Subject: Amendment Request for the Model 976 Series Type B Package

Enclosed please find Revision 5 to the Safety Analysis Report for the Model 976 Style Type B packages. This revision addresses a modification to the Model 976C package configuration to center the inner shield container more evenly within the drum overpack. With this re-centering, the Model 976C maximum Ir-192 capacity will increase from 800 Ci to 1,250 Ci. Also incorporated with this revision is the addition of Se-75 and Yb-169 as authorized contents for all package designations as well as some minor modifications to the cork and shield assemblies for some of the other package designations. The affected pages are identified on a list included with this amendment. A further detailed description of the specific changes to the SAR are included in the document titled "Revision Description for the Model 976 SAR from Revision 4 to Revision 5" also included in this request. Changes in the SAR are indicated by vertical lines in the right hand side of the page.

Revision 5 to the 976 SAR incorporates a modification to the cork configuration for the Model 976C container which increases the maximum Ir-192 capacity for this pa

FIGURE 5.a. SAMPLE SURFACE CORRECTION FACTOR DISTANCE CRITERIA

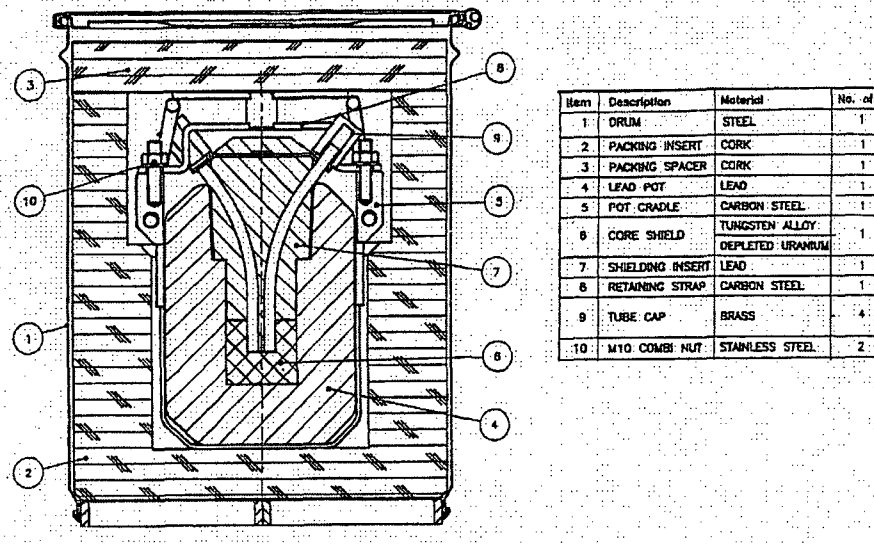
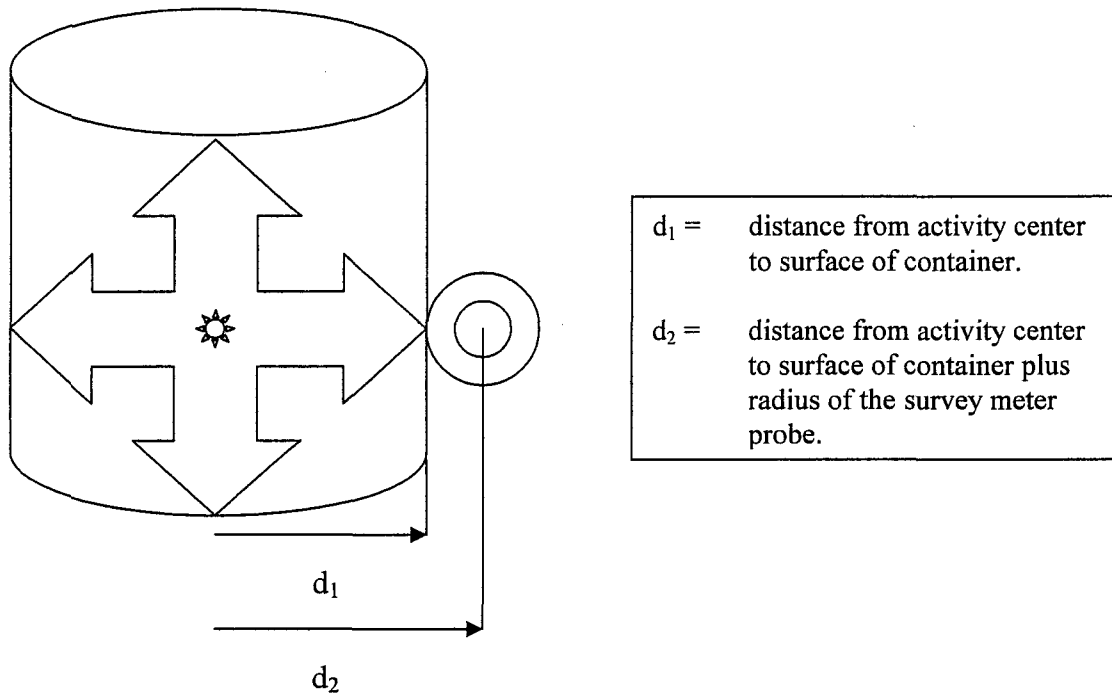
2-7	Table 2.6.1.a updated based on revised calculations from Sections 3.4.1.1 and 3.4.1.2.
3-1 through 3-3	Maximum Ir-192 content activity and decay heat values updated. Table 3.1.3.a updated based on revised calculations from Sections 3.4.1.1, 3.4.1.2 and 3.5.2.4.
3-6 and 3-7, 3-10 through 3-12	Maximum Ir-192 and decay heat value and associated calculations updated.
3-18 through 3-20	Maximum Ir-192 and decay heat value and associated calculations updated.
5-4	Table 5.1g revised based on re-profile of the Model 976C configuration with modified cork inserts.
5-6	Justification by assessment of acceptability of Se-75 and Yb-169 package capacities based on Ir-192 shielding results.
5-7	Table 5.3.1a and following comments updated based on revisions to Microshield calculations for new cork configuration for the Model 976C.
5-8	Figure 23 reference corrected to reflect Figure 5.a as shown in SAR. Figure 23 does not exist in the SAR.
